# El Paso LE- ADA Evaluation

**LE- El Paso TX, ADA Evaluation**  
**401 E Franklin Ave Suite 520**  
**Downtown El Paso, TX 79901**  
**Accessibility Evaluation**  
**Inspection Date: 06/16/2023**  
**Inspectors: Christopher Meza**

**LE- El Paso TX, ADA Evaluation - 401 E Franklin Ave Downtown El Paso, TX 79901**

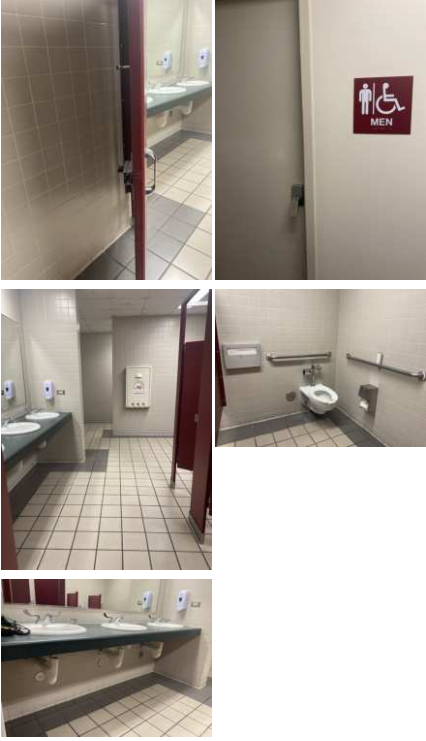
Finding Number	Area Description	Finding	As Built	Recommendation	Citation	Photos	Figure
4	Exterior of Property (Public): Parking Lot (9 Spaces) 8 Car 1 Van - Car Accessible Stall (R) Side	The van stall is missing a sign identifying it as a van accessible stall. Parking space identification signs shall include the International Symbol of Accessibility. Signs identifying van parking spaces shall contain the designation "van accessible."	There is no van identification sign for this spot. There are 9 total accessible parking stalls on location with only 1 labeled as van. Additional van spot is required due to size of parking lot.	<a href="https://www.access-board.gov/ada/#ada-502_6">https://www.access-board.gov/ada/#ada-502_6</a> There are 3 car accessible spot to right of entrance. Spot pictured in this finding has dimensions and marking for van. Recommend adding van sign to spot pictured in this finding.	2012 TAS Section: 502.6  2010 ADAS Section: 502.6
